**PLEASANT PRAIRIE PLAN COMMISSION MEETING  
VILLAGE HALL AUDITORIUM  
9915 39<sup>th</sup> AVENUE  
PLEASANT PRAIRIE, WISCONSIN  
6:00 P.M.  
JUNE 13, 2016**

- C. **PUBLIC HEARING AND CONSIDERATION OF A CONDITIONAL USE PERMIT INCLUDING SITE AND OPERATIONAL PLANS** to consider the request of BJ Korman for EMCO Chemical Distributors, Inc to construct a 62,160 square foot warehouse addition and associated site improvements at their facility located at 8601 95<sup>th</sup> Street LakeView Corporate Park.

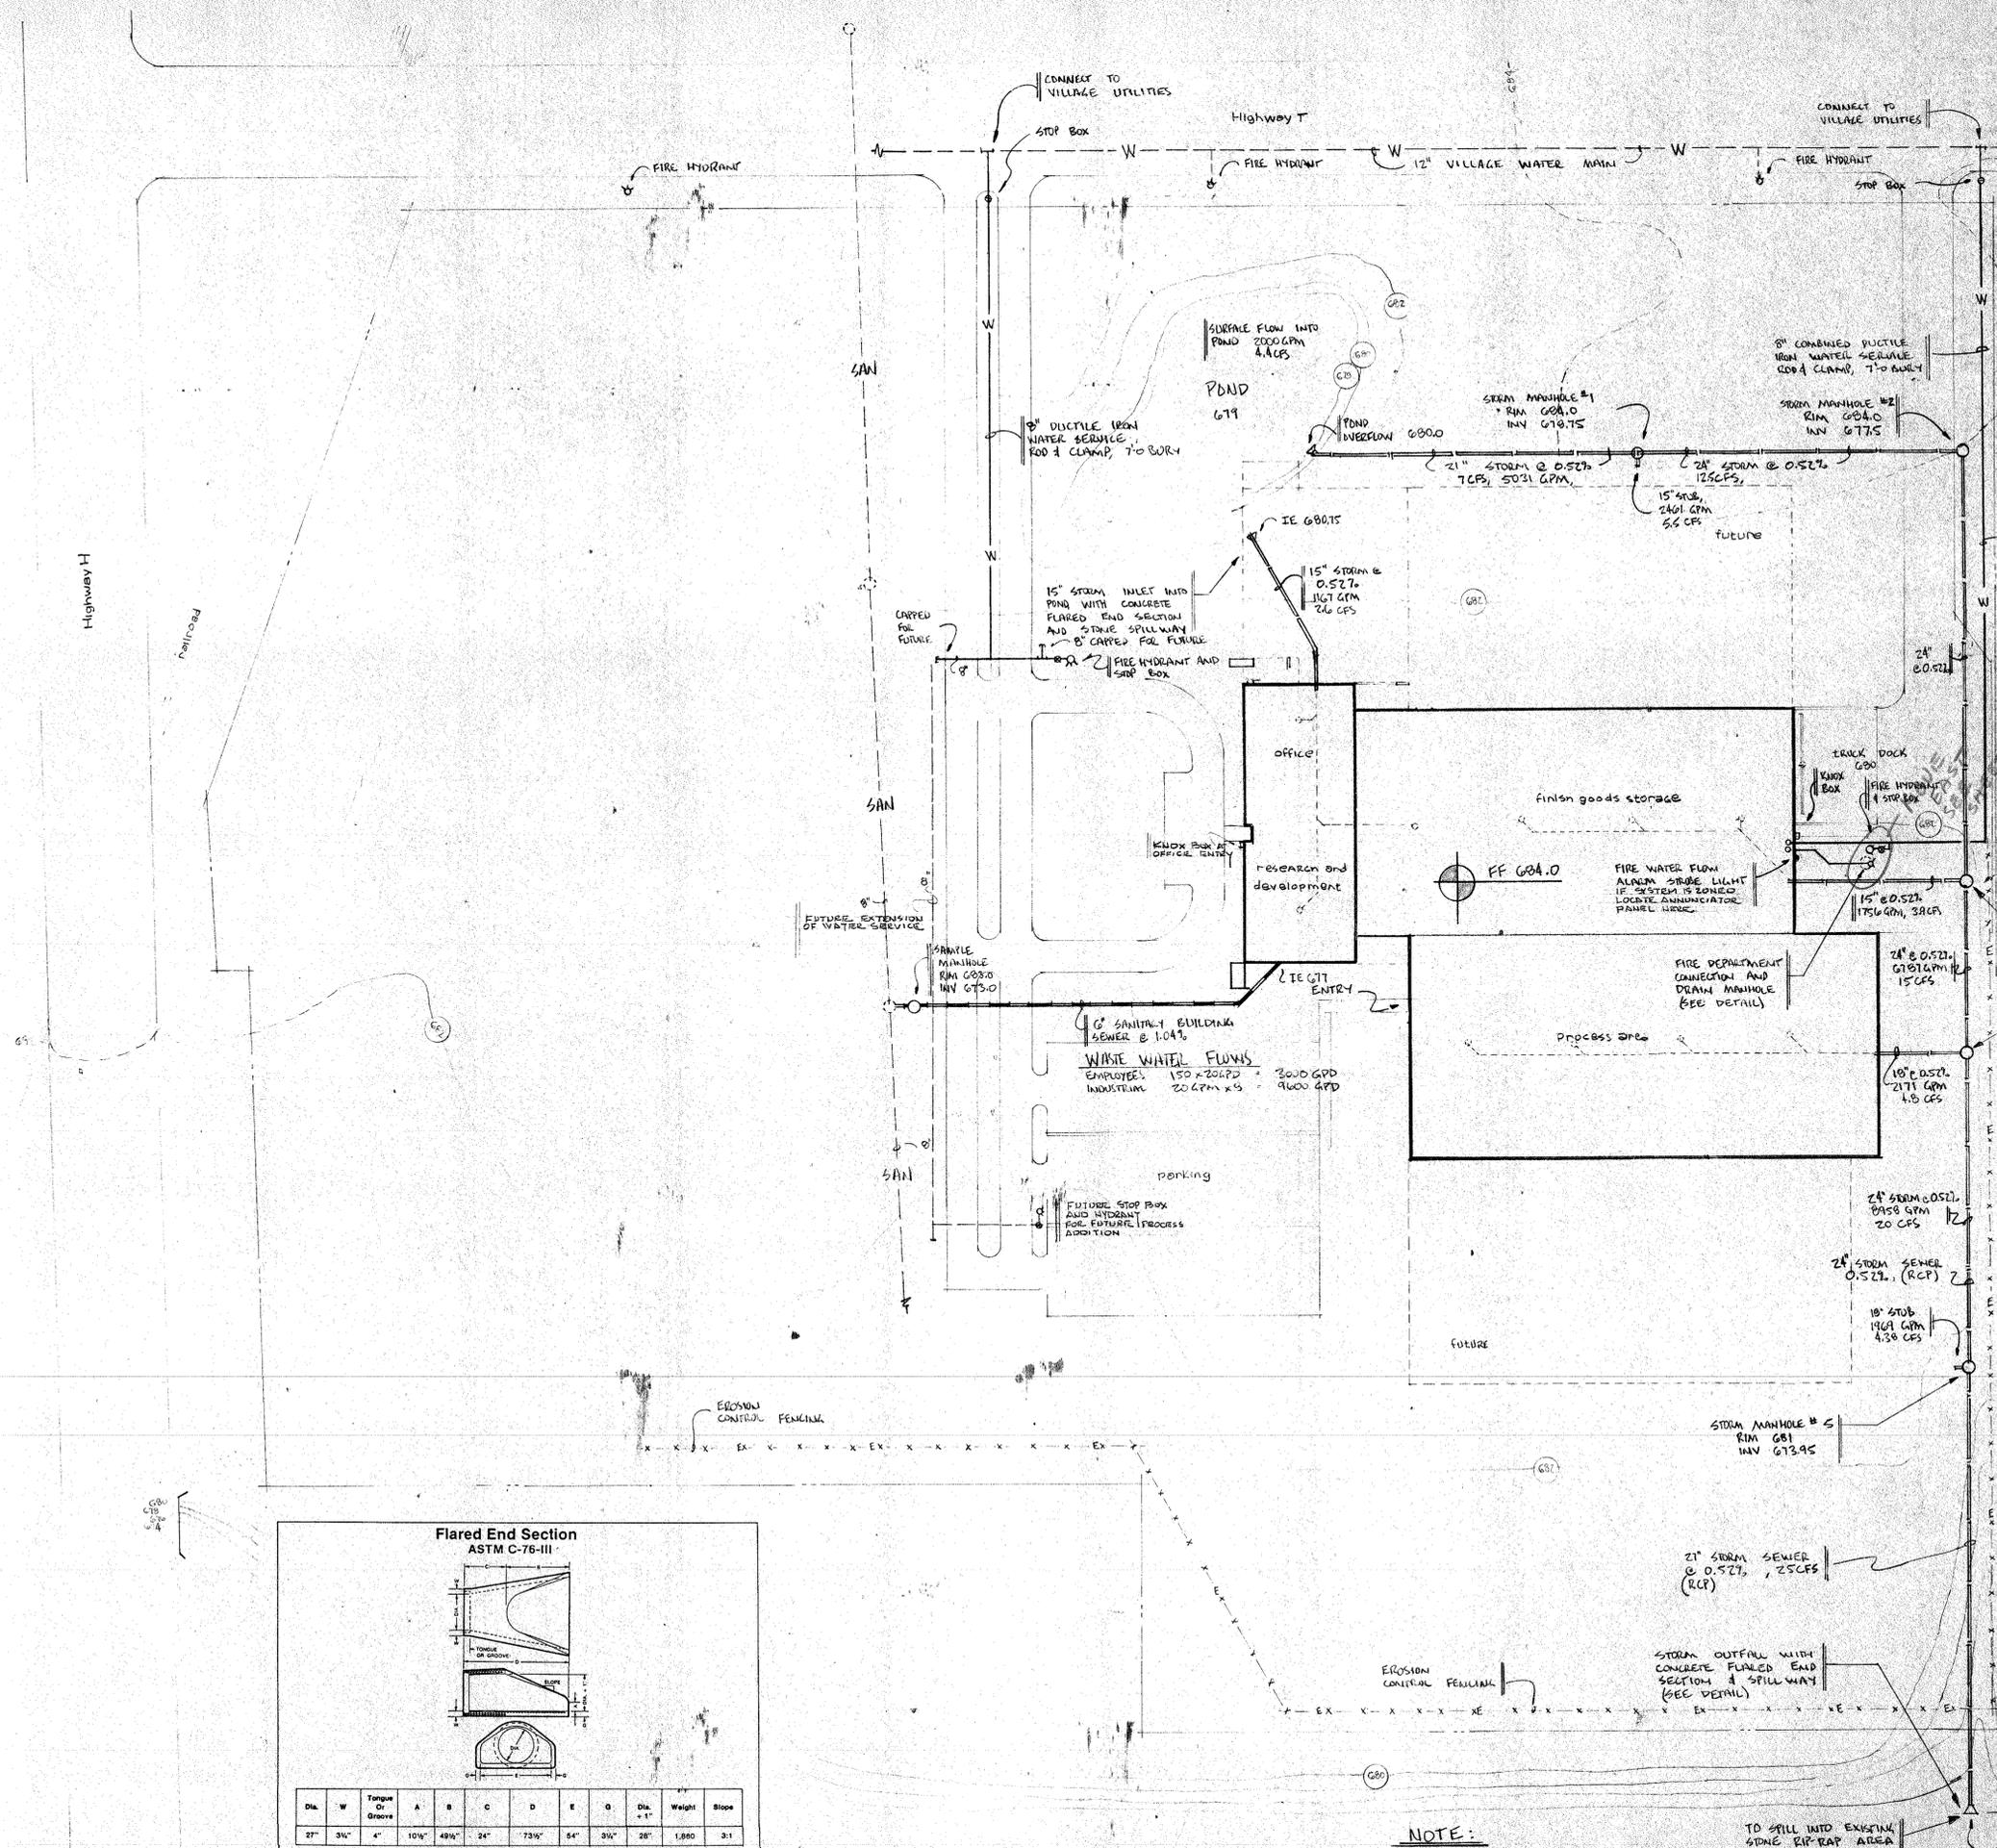
1. Provide additional information for the existing wet detention basin and associated existing site storm sewers and make any plan revisions as needed.
  - a. Provide information regarding existing storm sewer outfalls into the pond and pond outlet location and outlet storm sewer. Attached are existing plans on file showing some storm sewer locations, however, it is unknown if these are correct.
  - b. Provide the existing normal water elevation of the retention pond and calculated 100-year high water elevation.
2. Verify that the drainage entering the trench drains ultimately is routed to the existing retention basins located on the south side of the property.
3. Update the references of Chapter 405 to the newly Village adopted Chapter 405.
  - Chapter 405 of the Village of Pleasant Prairie Municipal Code "Design Standards and Construction Specifications", 2016 Edition.

4. South Yard Expansion: Provide the upstream and downstream invert elevations of the existing 24-inch culvert in which the expansion area drainage is directed to.
5. A landscaping plan shall be submitted for the project.
6. A separate fire protection plan was submitted. This plan shall be reviewed by the Fire Department, however, the design engineer shall check with the Fire Department regarding the following comments and make revisions as directed by the Fire Department.
  - a. The FDC detail is outdated. The updated Village pumper pad FDC detail shall be included, unless otherwise directed by the Fire Department.
  - b. The Village standard fire hydrant detail shall be included in the plan, unless otherwise directed by the Fire Department.

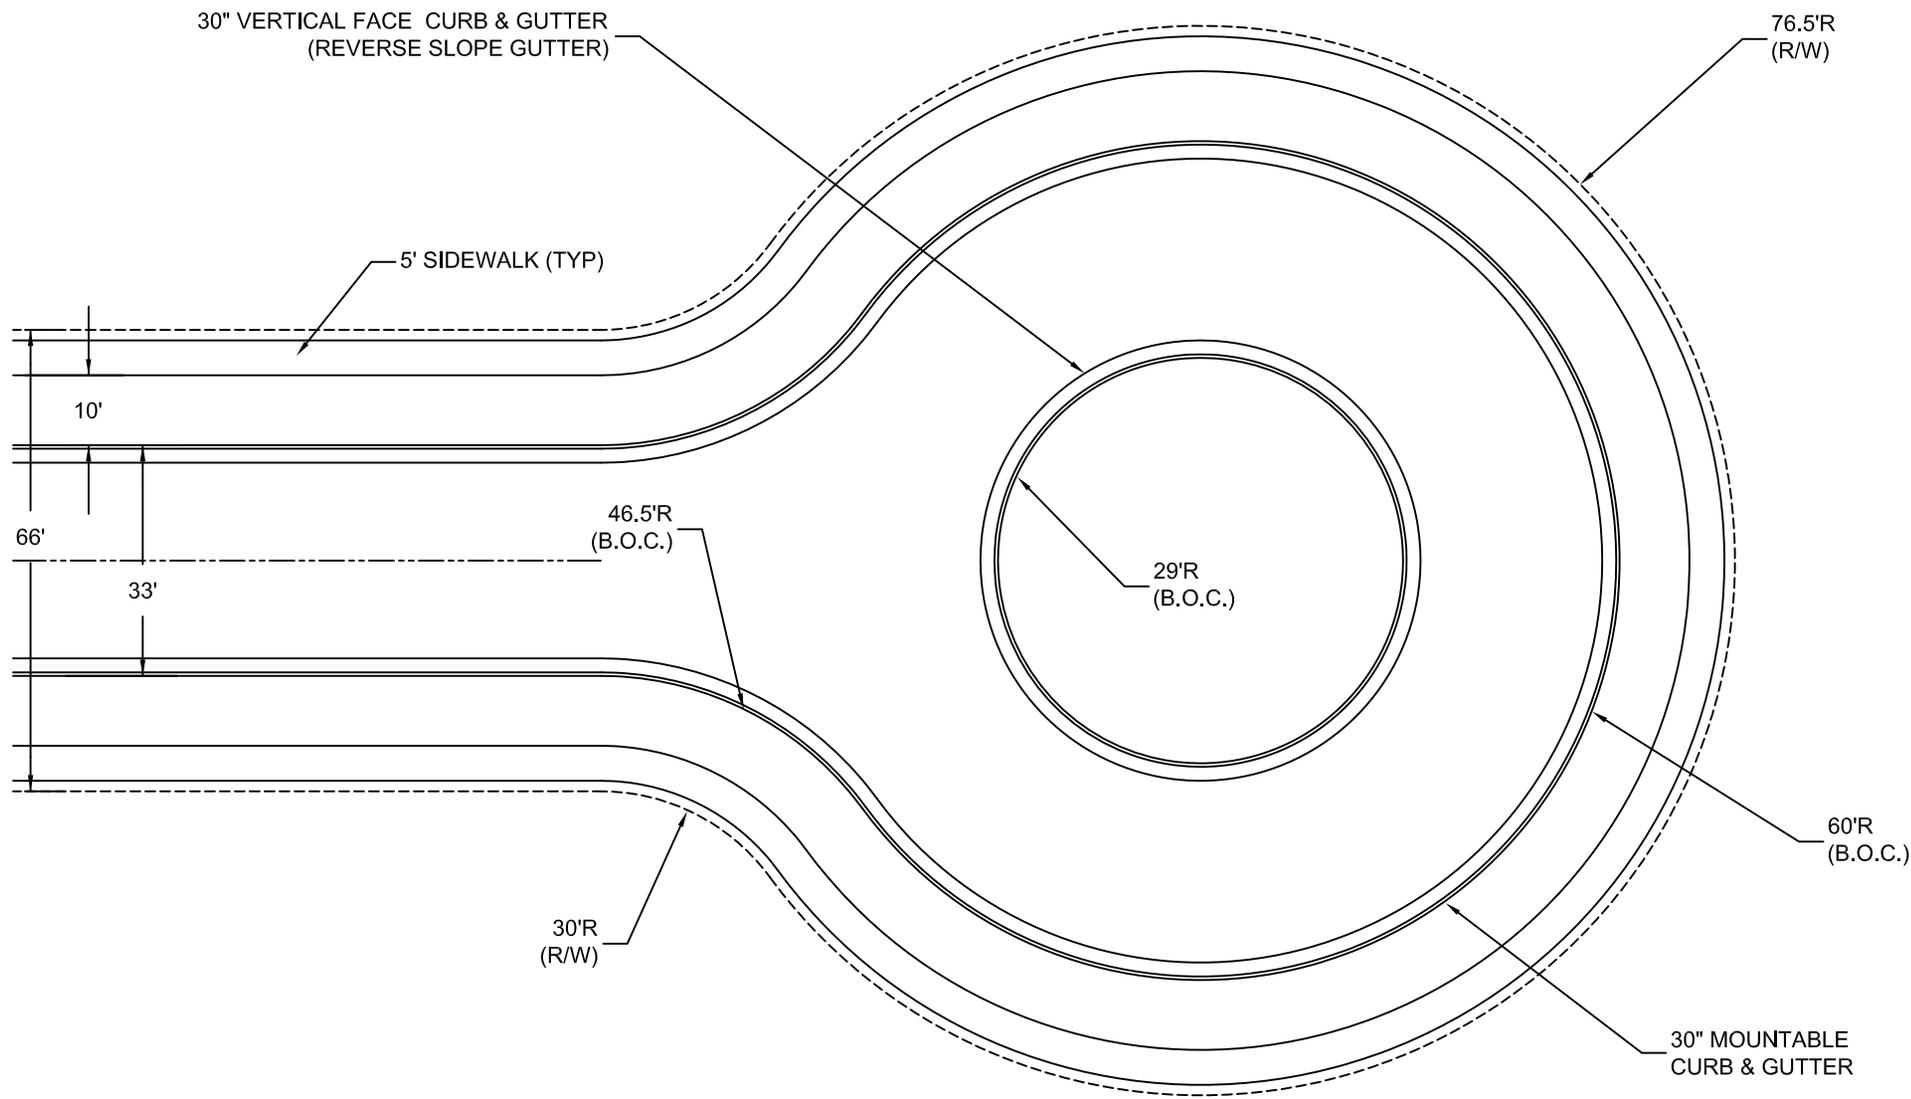
4. Provide sidewalk pedestrian crossings on Street C to Street A at both the north and south intersection legs.
5. The Village has adopting new/updated design standards and construction specifications. This development will be subject to these specifications / standards. The Village of Pleasant Prairie 2016 Design Standards and Construction Specifications can be found on the Village's website:

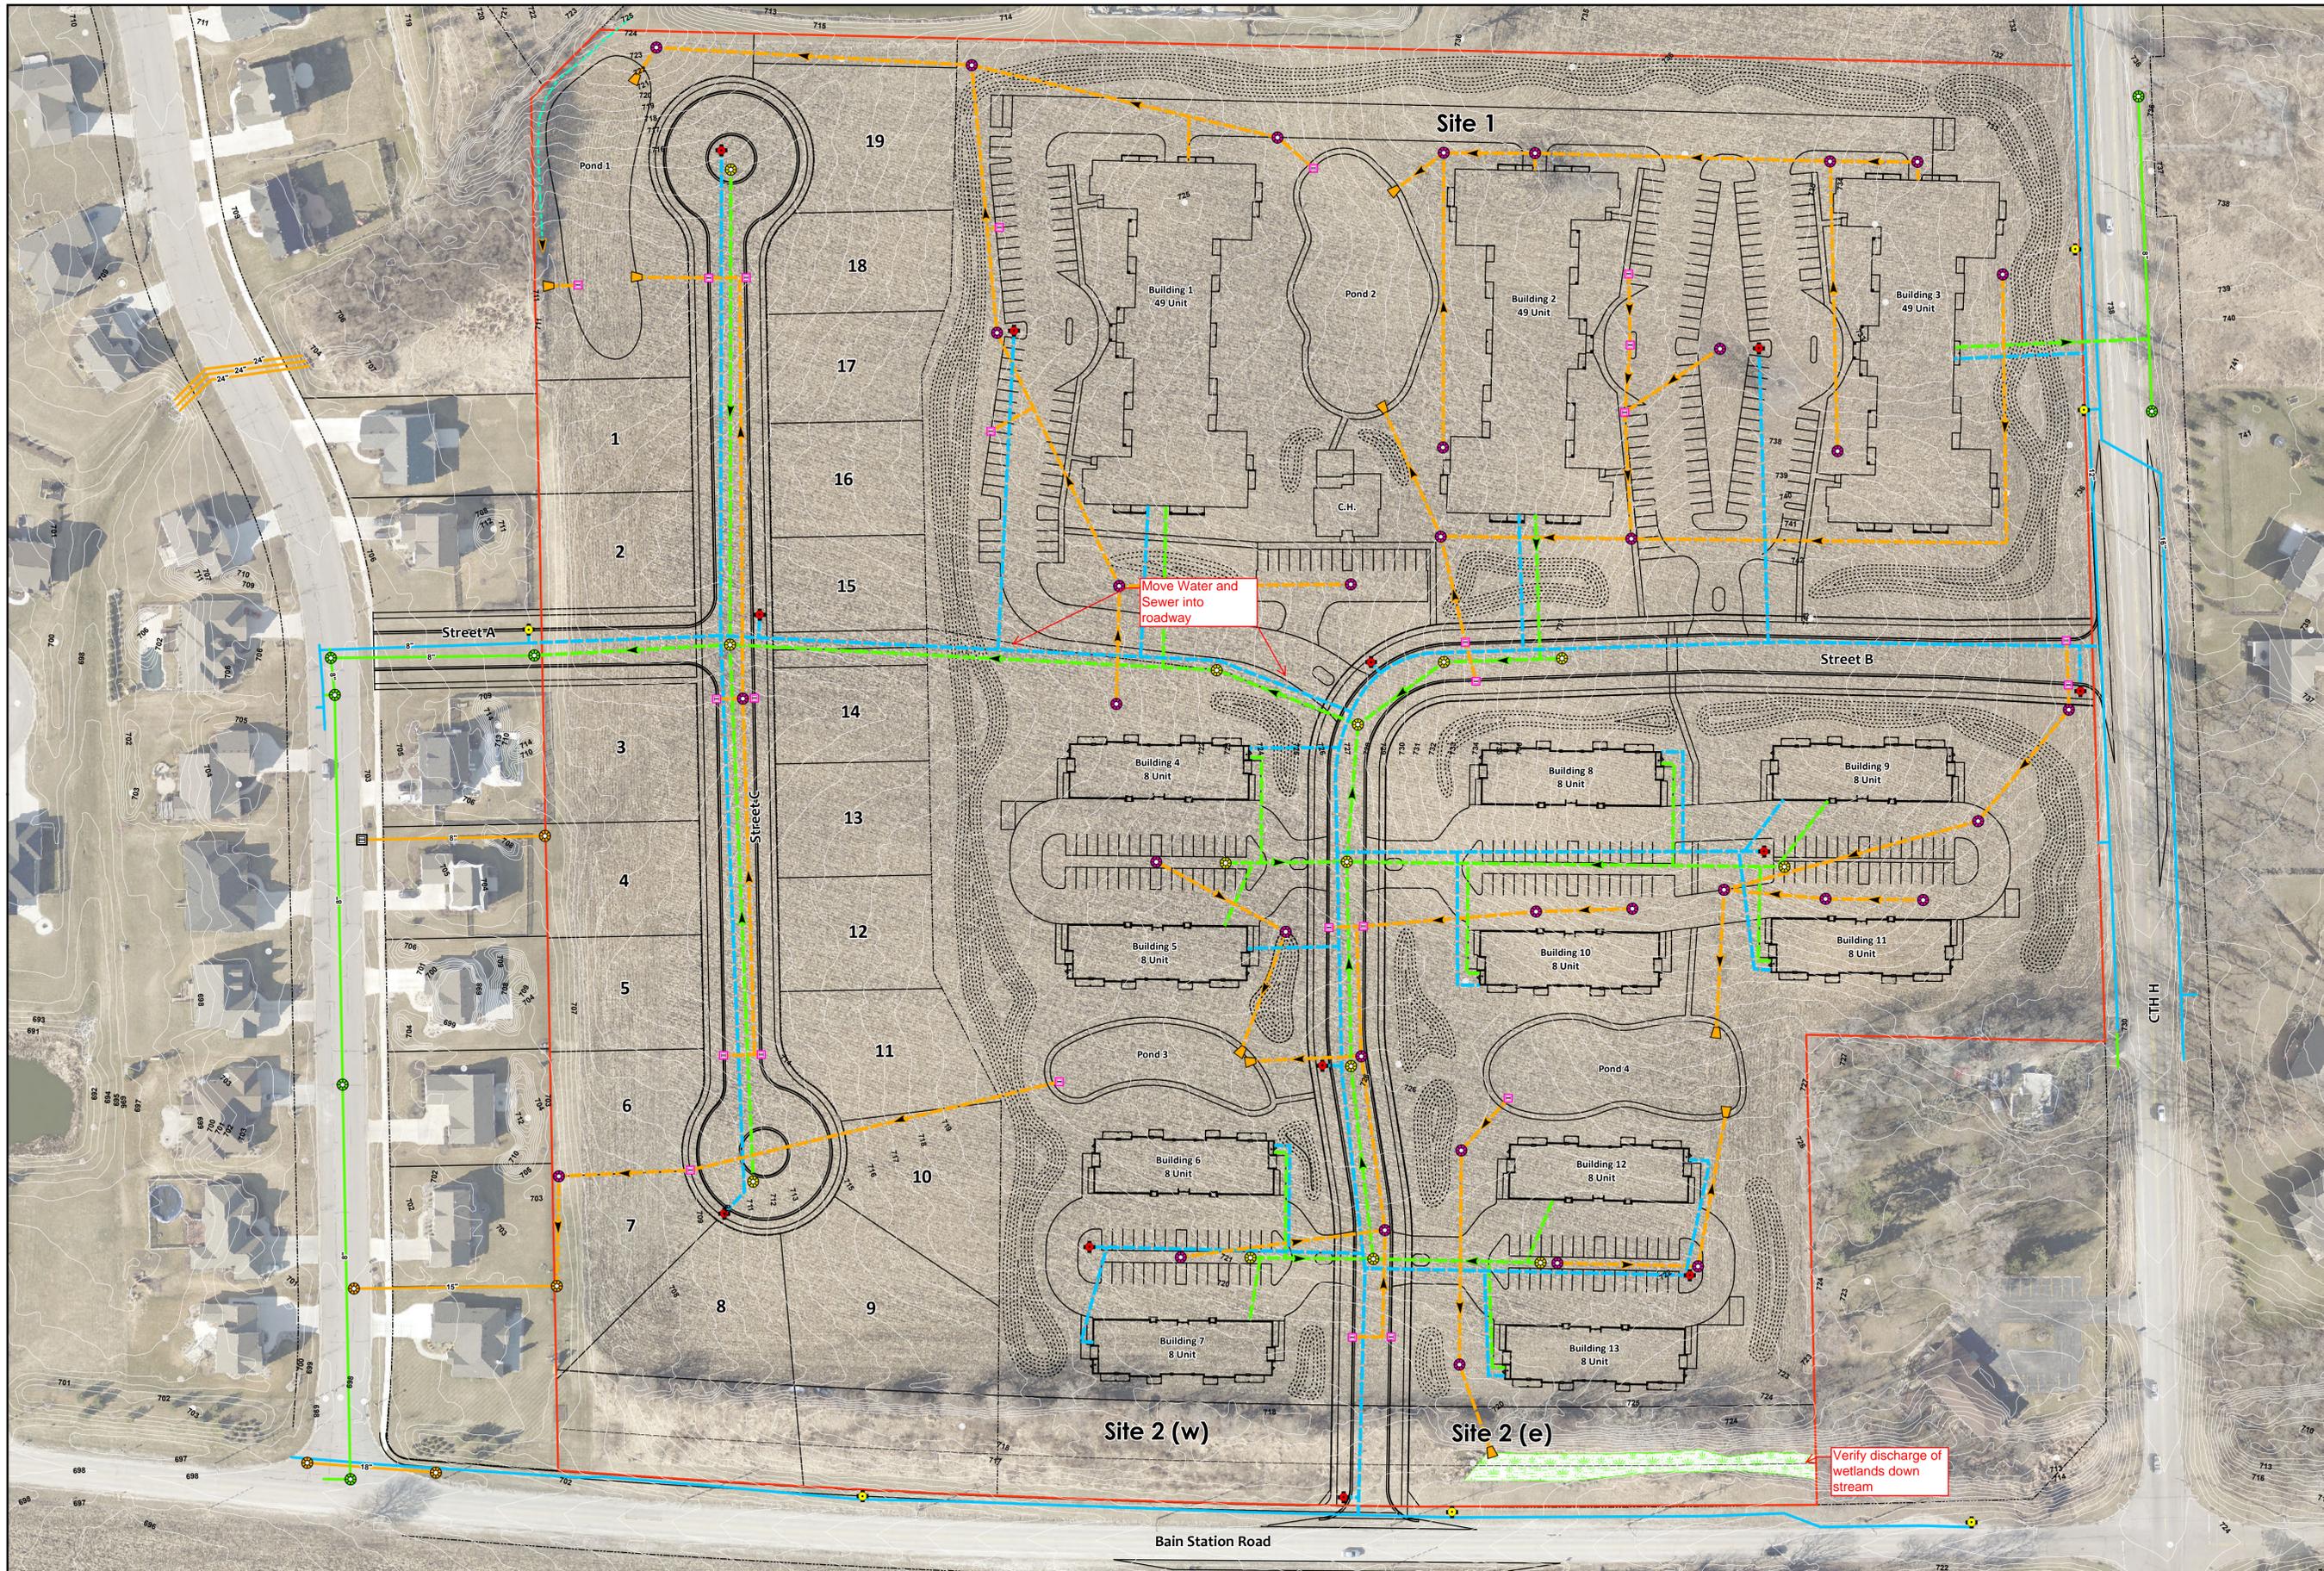
PAGE#	COMMENT
See attached Conceptual Utility Plan	Move water and sewer into roadway.
See attached Conceptual Utility Plan	Verify discharge of wetlands downstream.
General	Show details for bypass/decel lanes on CTH H and Bain St. Rd. (JH/5/23)
General	If the clubhouse will have a kitchen it will need a sampling manhole for the sewer. (TH-5/24)
